Amendments/Additional Information

Proposed:
 ALTERATIONS
 at
 FAIRVIEW
 THORNEY BROW
 FYLINGTHORPE

Drawing:
 AMENDED ELEVATIONS

Drawing No. 163/32
 Date: JANUARY 2017
 Scale: 1/100

N O R T H E A S T E L E V A T I O N

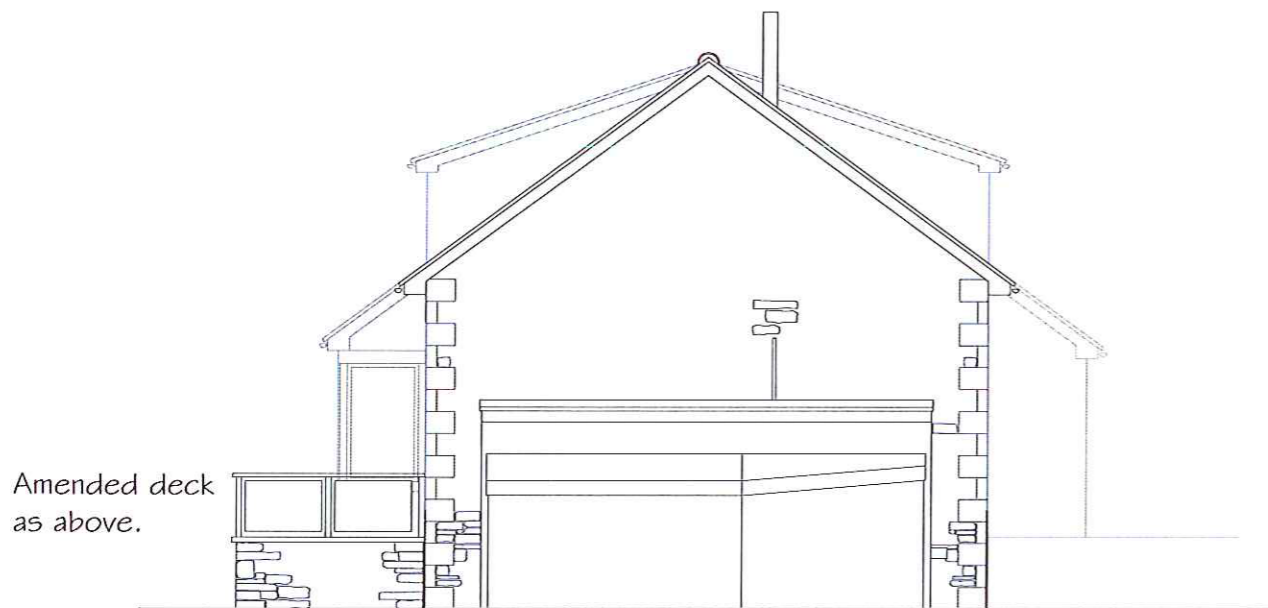
AMENDMENT:
 Omit timber decking.
 Add natural coursed stone supporting walls with natural stone flag paving.
 Guard rail to be powder coated circular hollow section steel. Top rail to be oval section steel also powder coated finish. Colour ref RAL 1015.
 Clear safety glass panels between supports.
 Design and installation by specialist proprietary manufacturer.

Amended deck
 as above.
